**Review of the
Union Electric Company
Integrated Resource Plan**

The Office of the Public Counsel

Technical Report

Case No. EO-2011-0271

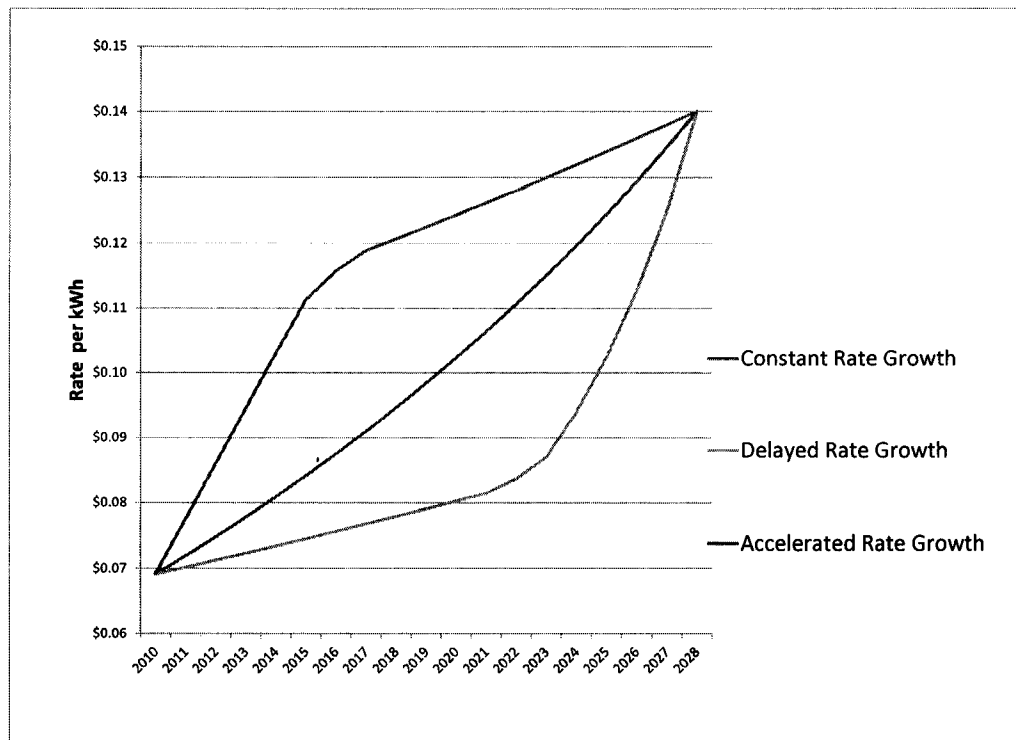
The customer satisfaction metric has two clear problems. Firstly, it awards the Constant Growth scenario a score twice as strong as the Delayed Growth scenario, despite the total ratepayer cost of the Delayed Growth scenario being 14% lower. Secondly, it awards the Delayed Growth and the Accelerated Growth scenarios equal scores, despite the Delayed Growth scenario costing 25% less than the Accelerated growth scenario. A well-tuned customer satisfaction metric shouldn't score moderately priced plans significantly better than inexpensive plans, nor should it score a costly plan equal to an inexpensive plan.

Secondly, the model doesn't weigh the rates by the probability of each scenario¹⁷, creating a bias in the rate results. Recall that there are ten scenarios with varying probabilities, ranging from four different "Energy Bill" Mandates each with 14.25% probability to the Business As Usual case with probability 0.5%. Instead of weighing the rates required by each scenario by that scenario's probability, the Company's model simply sums the rates and divides by 10, as if each scenario were equally likely. This modeling error results in future electricity rates related to the BAU scenario (a 1/200 chance) being substantially overweighed, whereas results from more likely scenarios such as Federal Energy Policy being substantially underweighted. This error is rectified in the corrected model Synapse produced and applied to the final set of candidate resource plans.

Finally, in direct contradiction to CSR 240-22.060 (2), the customer satisfaction calculation in the model uses a simple mean average rate rather than a levelized annual average rate.

The Relative Benefits of the Energy Efficiency Scenarios

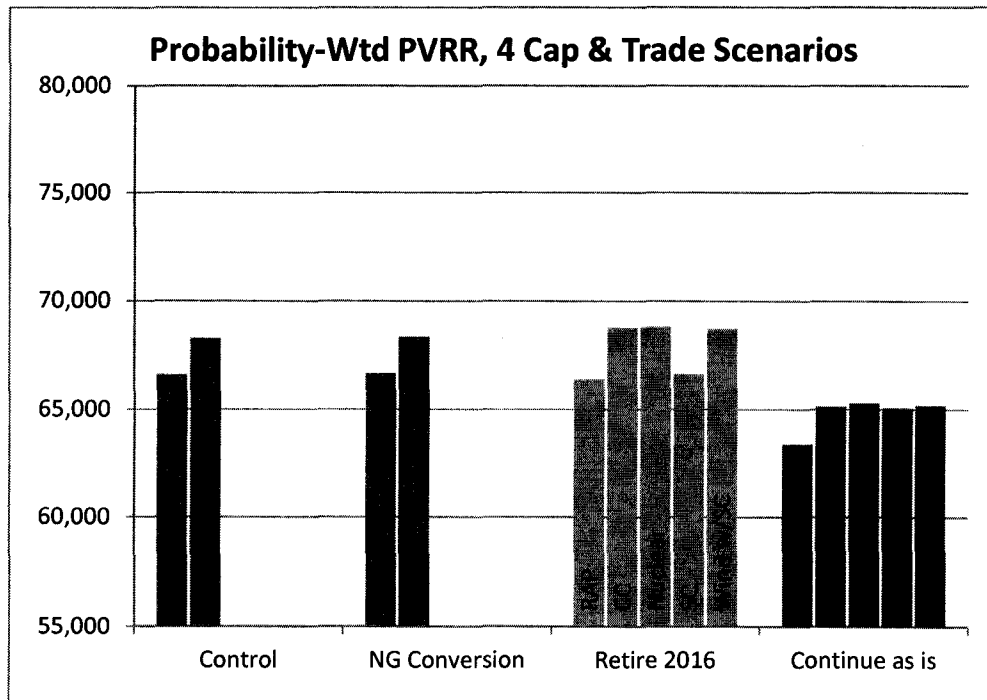
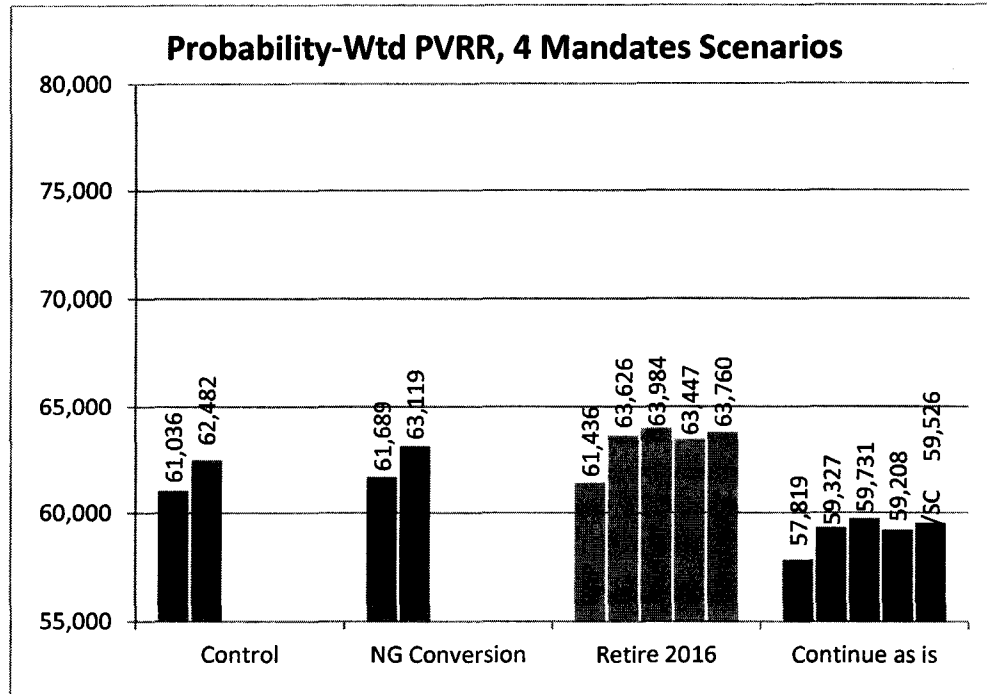
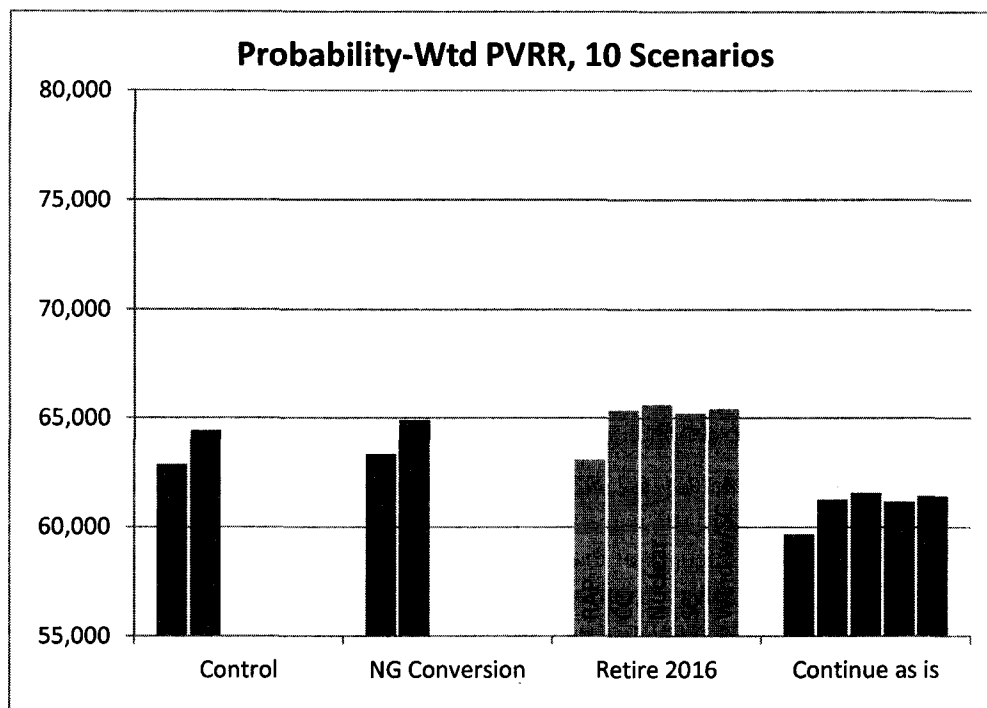
One of the most striking results of the risk analysis at this point is the finding that the plans containing the RAP level of energy efficiency clearly result in the lowest PVRR under all scenarios and sensitivities. First, UE conducts some comparisons of the RAP scenario with the Capacity Calibrated Portfolio (CCP) scenario, which combines energy efficiency and demand response at just enough amounts to defer future capacity additions. The CCP scenario includes less energy savings than the RAP scenario but greater amounts of demand response than is included in some plans with the RAP level of energy efficiency. Under all sensitivities run by the Company (including Meramec controlled, Meramec converted and Meramec retired in 2016), the RAP plans result in lower PVRR than the CCP plans.²⁰ Based on these findings, the Company decides that further analysis of plans with CCP is unnecessary.²¹

Second, UE conducts several risk analysis sensitivities of the 14 candidate resource plans. Every sensitivity conducted demonstrates that the RAP efficiency plans result in the lowest PVRR. In the cap-and-trade scenarios, RAP has lower cost than combined cycle (CC), nuclear, simple cycle (SC), and wind, whether Meramec is controlled, converted to natural gas, retired in 2016, or allowed to continue as-is. Under the environmental mandate scenarios, the same is true: RAP performs best. When all ten scenarios are probability weighted, RAP again turns out to be cheapest.

This point is demonstrated in the charts below. These charts were derived by simply rearranging the data presented in Figures 9.16, 9.17, and 9.18 in Chapter 9. The PVRR results for the RAP plans were placed directly next to the PVRR results for comparable Meramec scenarios, to provide an indication of how much money the RAP plan can save relative other plans in a directly comparable scenario. As indicated in the charts, the RAP plans result in the lowest PVRR under all of the risk analyses.
